UNITED STATES PATENT AND TRADEMARK OFFICE

APPLICATION NO.	FILING DATE	FIRST NAMED INVENTOR	ATTORNEY DOCKET NO.	CONFIRMATION NO.
09/863,013	05/22/2001	Milan R. Kokta	3177.1000-000	7269

Office Action Summary

DETAILED ACTION

**FIG. 1**

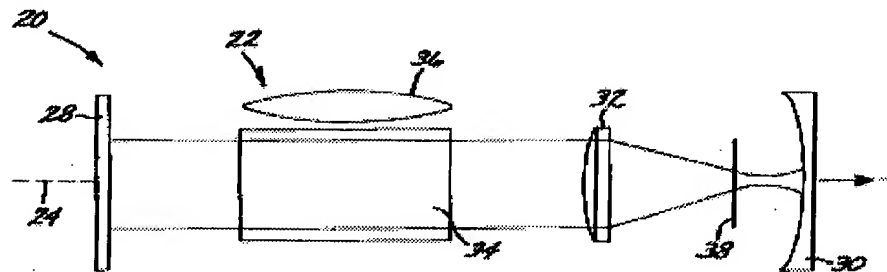
Regarding claim 16, Stultz et al. disclose a laser system, comprising:

- a). a laser resonator cavity defined by a flat mirror (28) and an out coupler mirror (30), flat mirror (28) and said outcoupler (30) mirror oriented to form an optical resonant axis (24);
- b). a lasing element (34) within the laser resonator cavity;
- c) Optical pumping (36) means proximate to said lasing element
- d). A saturable absorber Q-switch (38) lying along the resonant axis. (See Fig 1 below and column 3, line 14-21).

But Stultz et al. do not disclose the Q-switch including a monocrystalline lattice having a formula $Mg_{1-x}Co_xAl_yO_z$. However, Konstantin v. Yumashev discloses a monocrystalline lattice having a formula $Mg_{1-x}Co_xAl_yO_z$ where x, y, z are still the range of the invention (See on the right column, first paragraph, page 1).
